MITIGATION PLAN WITH AS-BUILT DRAWINGS

BROWN MARSH SWAMP STREAM AND WETLAND RESTORATION SITE

Subject: Mitigation Plan Review for the Brown Marsh Swamp Stream Restoration Project
Lumber River Basin – CU# 03040204
Robeson County, North Carolina, Contract No. # D06038-A

**RE: Response to EEP Comments on Mitigation Plan Review for Brown Marsh
Swamp Stream and Wetland Restoration Project
Lumber River Basin – CU# 03040204
Robeson County, North Carolina, Contract No. # D06038-A**

AS BUILT PLANS	
BROWN MARSH SWAMP	
CONTRACT: 16-D06038	COUNTY: ROBESON
DESIGNED BY: RVS	DATE: 01/08
CHECKED BY: RKW	SHEET 3 OF 8

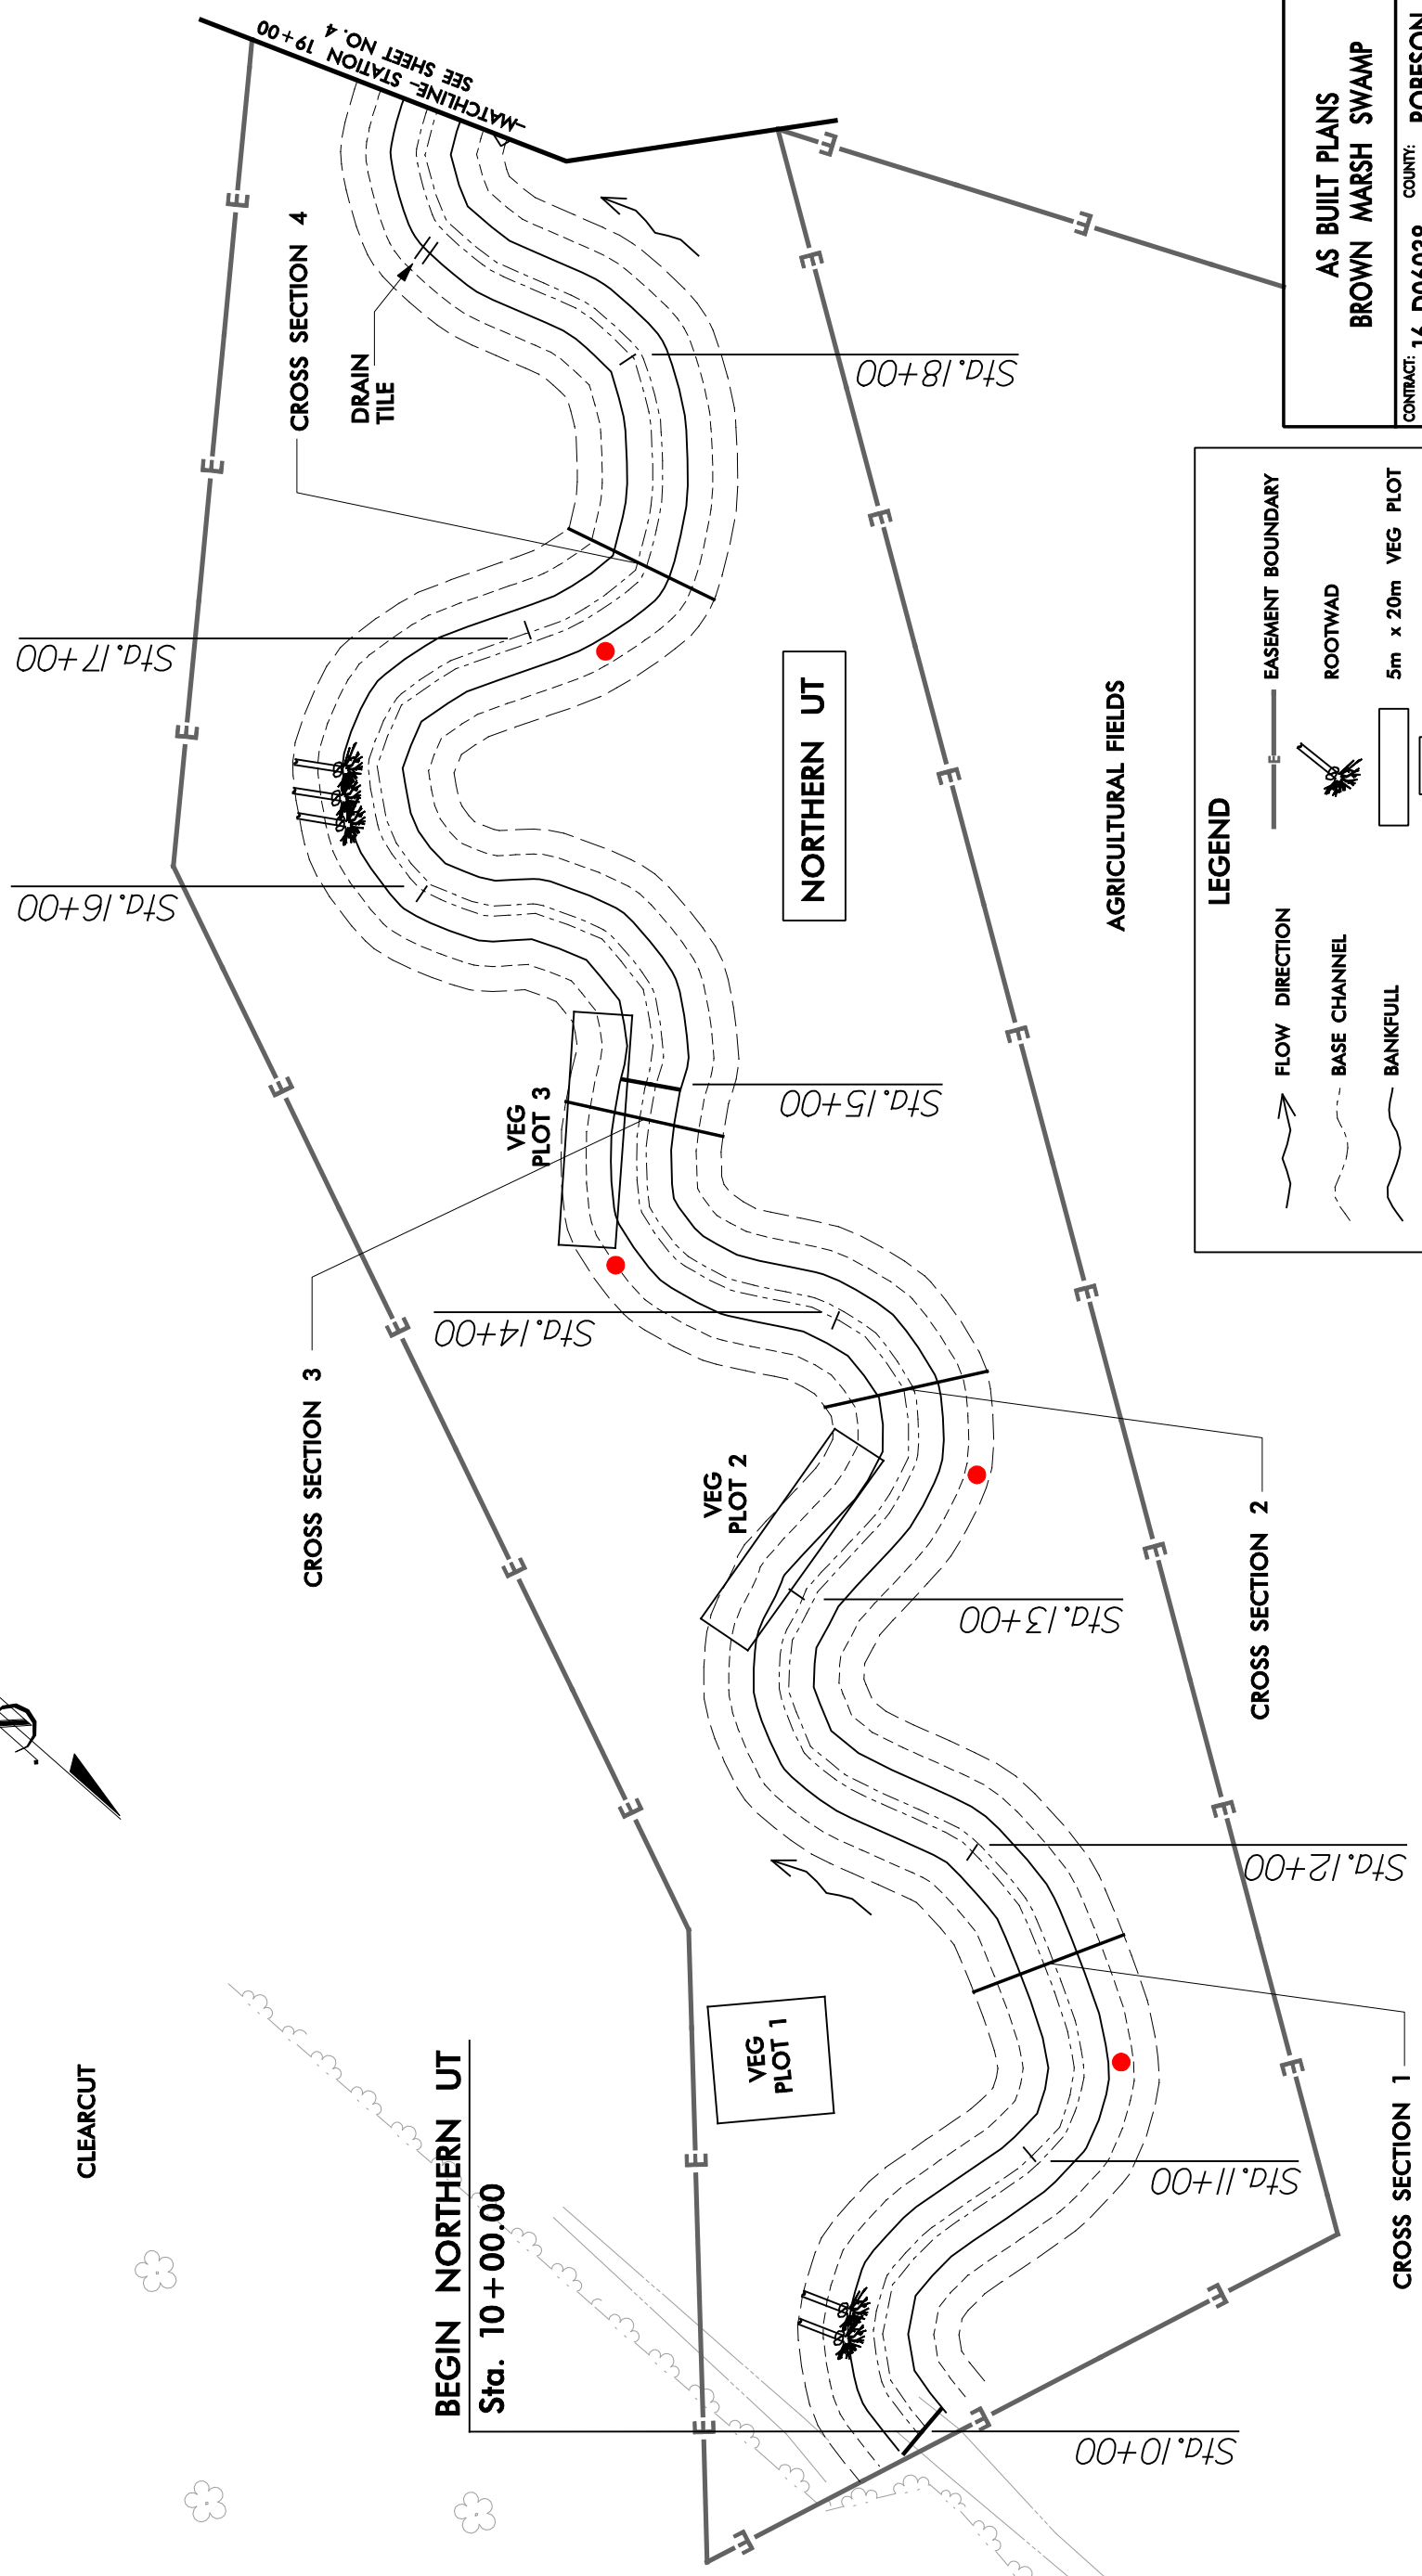
Page 3 of 8, As-Built Drawings – At approximately station 18+50, the plan view indicates "Drain Tile" which appears to be directed into the stream. Is there in fact tile drainage through the buffer of the stream? Please explain.

3. EEP Comment: **Page 3 of 8, As-Built Drawings** – At approximately station 18+50, the plan view indicates "Drain Tile" which appears to be directed into the stream. Is there in fact tile drainage through the buffer of the stream? Please explain.

Response: The drain tile that is shown on Sheet 3 of 8 is a drain tile that comes from adjacent farm fields. The tile is located approximately 3.0 feet below the top of existing ground through the stream buffer. The tile was day lighted to drain across the floodplain (at an elevation that is slightly lower than the floodplain elevation) and drains back into the channel at the location shown in plans. Flow from the drain tile is concentrated across the floodplain using a "Flood Plain Interceptor" (detail shown on sheet 2a of Construction Plans) which allows the flow back into the restored channel in a stable manner.
